Clump Point Jetty

January 2012

At the end of 2011 the Cassowary Coast Regional Council (CCRC) engaged [GHD Consultants](#) to meet with Mission Beach stakeholders concerning the future of the Clump Point Jetty. The consultants were supplied with a list of stakeholders by the CCRC which included representatives from tourism, commercial boat operators, traditional owners and government departments.

Fig 1

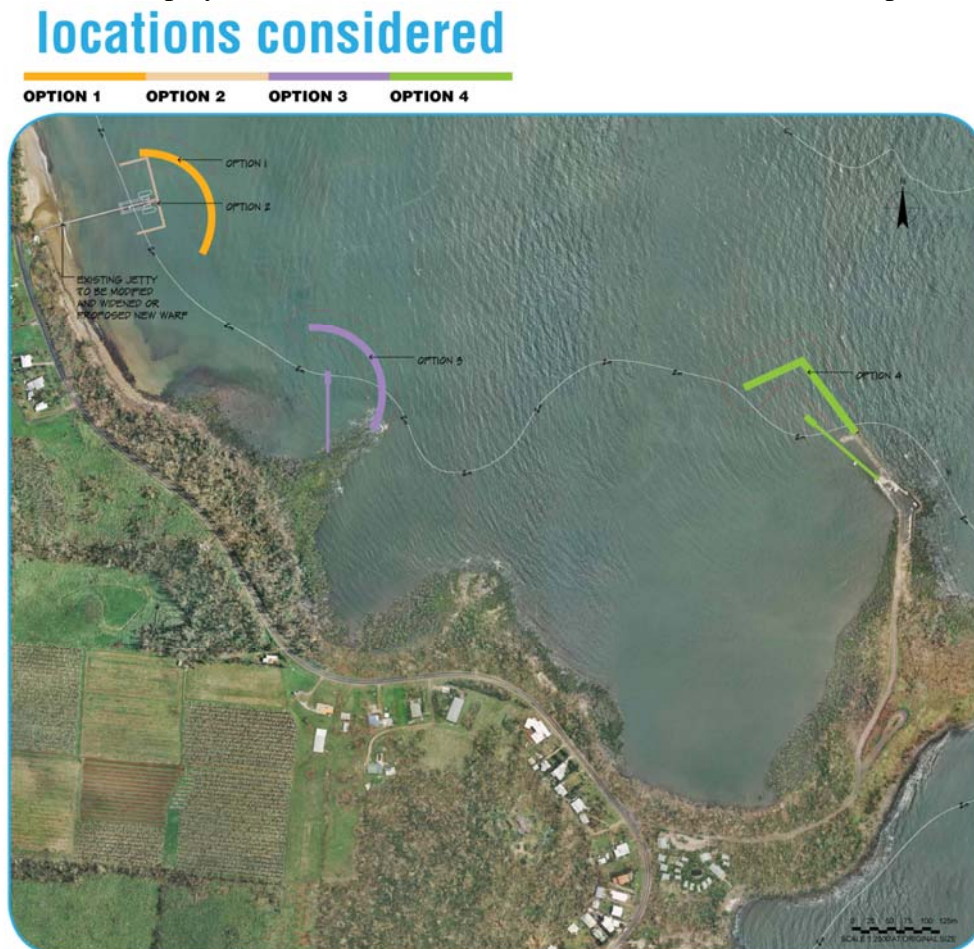
These options have not been backed by engineering or feasibility studies. As presented, none of them are environmentally acceptable because they include rock walls and a large concrete embayment.

Fig. 2

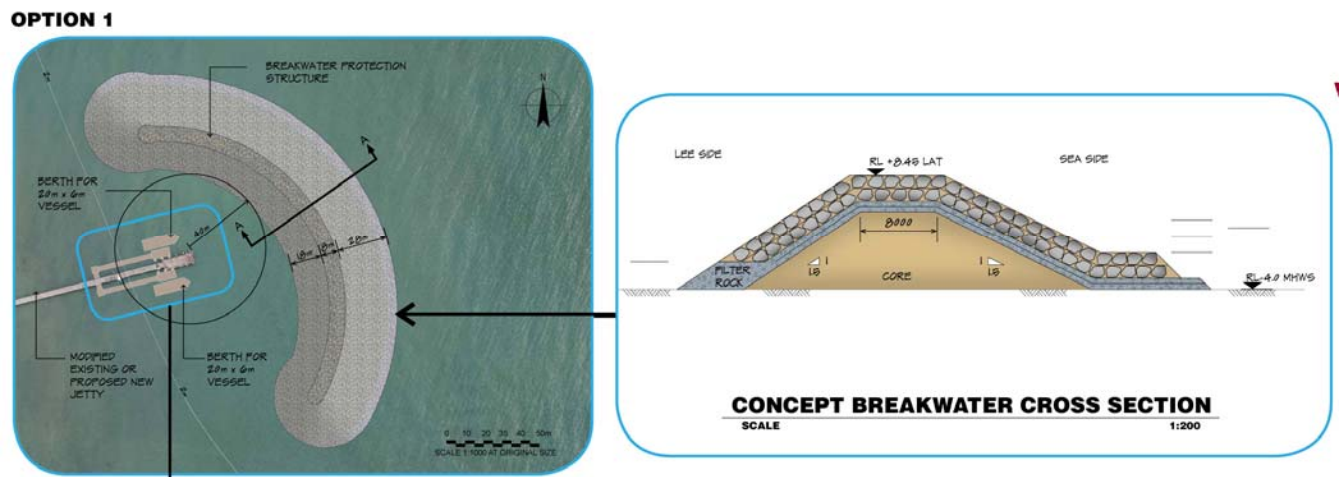
Option 1 (fig. 2) is the same as **Option 2** (fig 7) except that a rock breakwater is proposed instead of the high concrete wall. There were no drawings for options 3 or 4 but the summary boxes (fig 3) outline some of the drawbacks of the designs *i e adverse environmental impact, difficult vehicle access, services, car parking not available*

Fig. 5a (Not to scale)

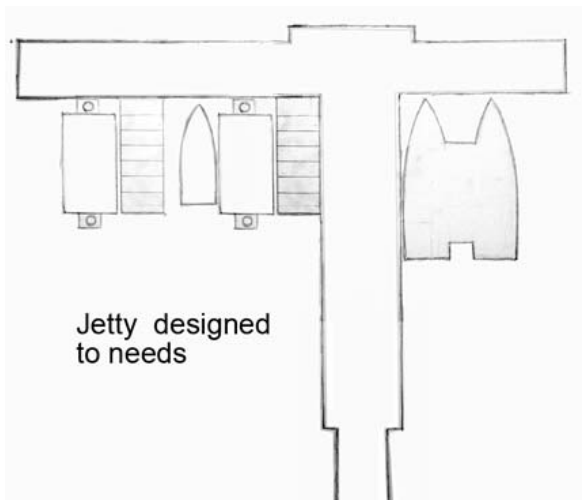
A better option than the drawings presented is a T-shaped or L-shaped jetty, accompanied by two sets of steps allowing access to the water at all stages of normal tides. A further short cross piece could be added part way along the jetty, complete with cyclone resistant shade, as a fishing alcove for locals and visitors. (fig 5)

A holiday recreational atmosphere can be encouraged by suitable permanent (metal) "sail" coverings (as on The Strand Townsville, fig 5b).

At least one of the sets of steps should lead to a pontoon riding on its own piles and suitable for use by recreational and small commercial craft.

The piles need not be higher than a metre or so above Highest Astronomical Tide (HAT) if the pontoons are sinkable readily detachable for safer stowage ashore (where?) should a cyclone threaten.

Fig.6

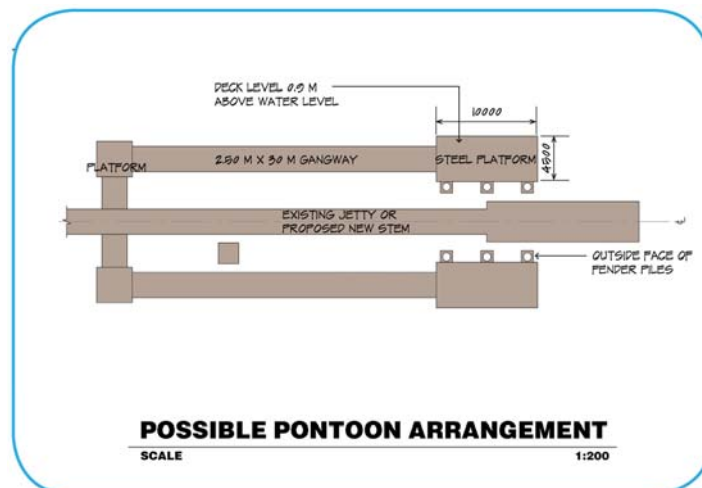
The use of pontoons has some merit, but not as pictured (fig 6), on this exposed high-energy coast.

- **Placement of pontoon strings in a wave break or wave build-up area.** The consequences of strong wave action acting on a series of unsecured pontoons have not been taken into account.

- **The long parallel pontoon walkways are free to move** in any direction (including sideways). The ramps from the jetty to the pontoons must be 20 to 30 metres long if they are not to be too steep for safe access at the lowest tides. In the pictured arrangement in this exposed setting, bridging ramps will suffer extreme stress and wear and will break free in strong weather.

- **Very high piles required.** To accommodate the combination of HAT and wave action in normal strong weather (eg 20 - 25 knots), the pontoon piles will have to reach a good 6 metres above LAT. Depending on the height of the seabottom at this location, this would require very long piles structurally strong enough (diameter, wall thickness, solid or hollow etc) to stand the required height (say 10 metres) above the seabottom, plus a further length of some metres driven into the seabottom.

- **Human safety has not been taken into account.**
 - There are always people who walk past barriers, enjoy the excitement and thrill of riding a bucking pontoon walkway in rough weather, or just want to defy authority. Is it wise to provide a way for people to access such long unsecured pontoons in this exposed and active area? The jetty, by comparison, provides stable footing.

- The end steel floating platforms will be lethal in strong weather if not rendered sinkable. CCRC staff would need to be dedicated to carry out this task before it became unsafe to do so, and to keep people off the walkways, every time strong weather threatened.

Fig. 7

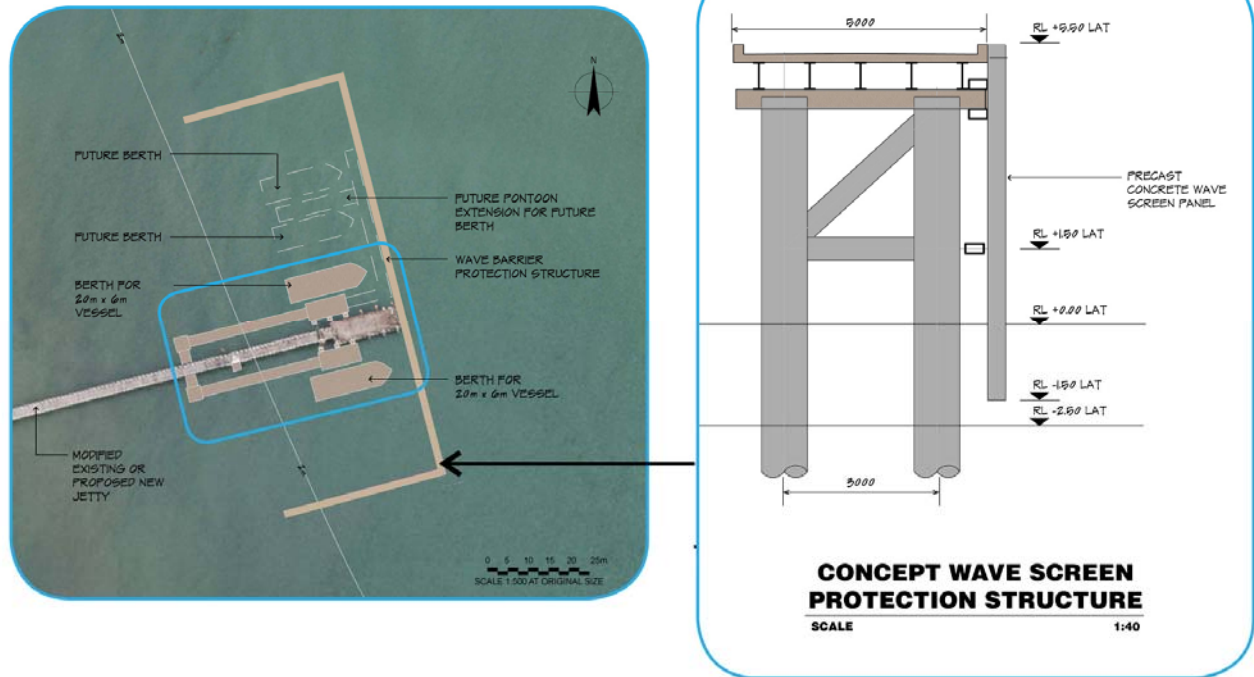
Stage 3 A straight jetty with a large (100m long x 30m wide) embayment created by an additional jetty or wharf construction straddling the original jetty's outer end. (fig 7 & 9)

Attached to this jetty are proposed solid concrete walls rising 5.5 metres above Lowest Astronomical Tide, turning the whole into an ugly 100m long wharf (with 30 metre side arms) to create a crude marina.

Information accompanying GHD Option 2 quotes a cost of \$16m above the cost of the jetty repair.

\It makes no reference to any environmental impact and on the information day it was stated by the consultant representative that this option would be approved by DERM. An extra information box (below) makes the point “future proof to enable additional features to be installed in the future”

This is the more obviously unacceptable of the drawings presented by GHD as additions to the existing or replacement jetty. (fig 7 & 9)

- It is clearly a marina by stealth. The only reason to create a solid structure of this size and shape is for storage of vessels.

- Although the concrete "screen" as proposed has no immediate contact with the sea bottom, it is in fact a solid wall suspended on many piles, creating a large embayment with all the hydrological, environmental and visual impacts of a rock wall, including light exclusion.
- The concrete wall does not cater for all states of tide (normal conditions). At Lowest Astronomical Tide (LAT) very little of the wall is in the water, so some wave action will penetrate to the boat landing and storage area.
- Visually the concrete walls are extremely ugly - at low water this 160 metre-long, sheer vertical concrete structure will tower 5.5 metres above the water (and will require many ladders/steps to access the water); and - what an invitation to graffiti!! 160 m x 5 m x 2 sides!! - as one sees on concrete walls in industrial ports. Because that is what it will look like.
